Lea Castle Farm

Planning Application for Sand and Gravel Extraction

Hydrological & Hydrogeological
Impact Assessment and my
Interpretation of the Information
Provided by BCL Hydro on the
behalf of the NRS Aggregates Ltd

Table 4 Statutorily Protected Sites within 3km of Proposed Development		
Site Name	Distance* and Direction from Proposed Development	Description
Hurcott Pasture	640m SE	TBC
Hurcott & Podmore Pools	660m S	TBC
Stourvale Marsh	820m SW	TBC
Puxton Marshes	970m SW	TBC
Kinver Edge	2,550m NNW	TBC

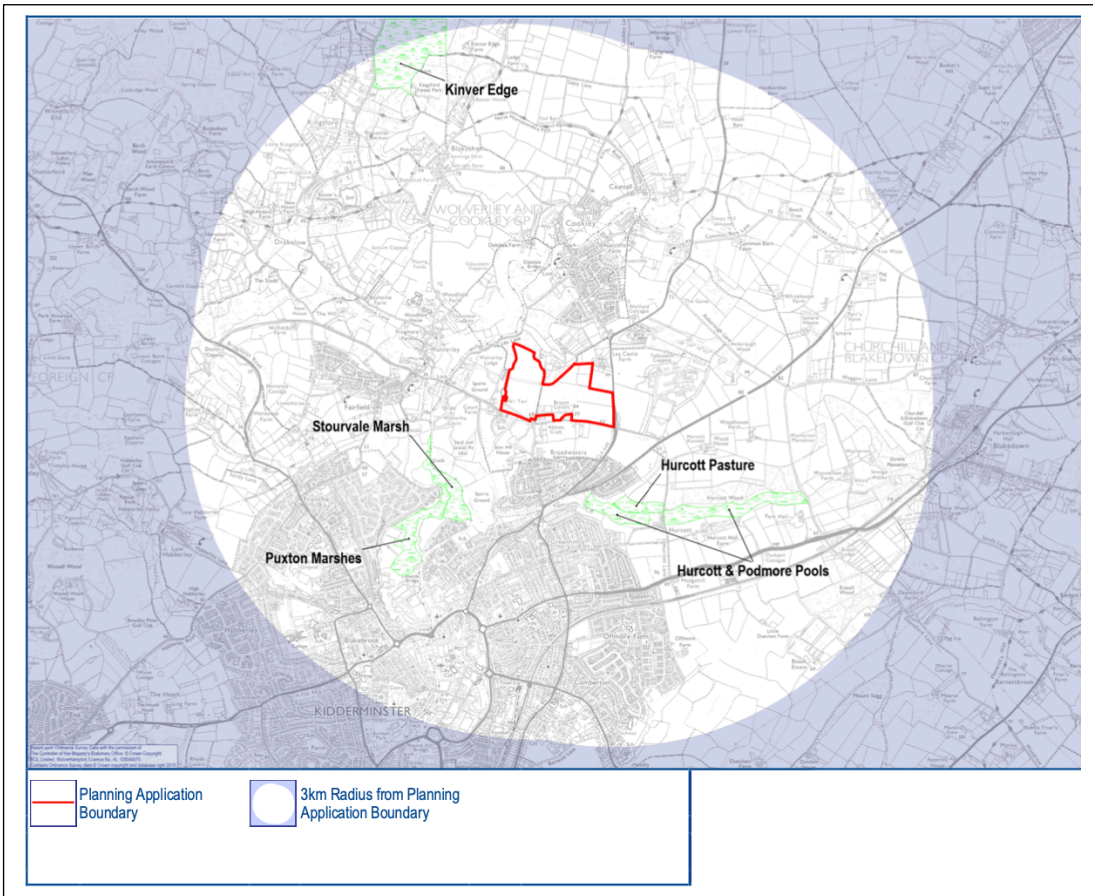
The data below is from BCL Hydro report and there is no definite answer either way as to the possibility of pollution through the water table affecting these SSSI

The “accidental” failure to address potential damage to trees in the ancient wet woodland at Hurcott Woods or the potential for pollution to the water table affecting these sites seems all the more concerning when set against concerns specifically raised in the Worcester County Council Scoping Opinion dated 29th June 2018 produced in relation to the quarry application, which were never addressed.

I feel that the lack of information on the possible pollution as the SSSI warrants further investigation. For example, would there be a geological survey specifically targeting the prospect of contamination of these SSSI?
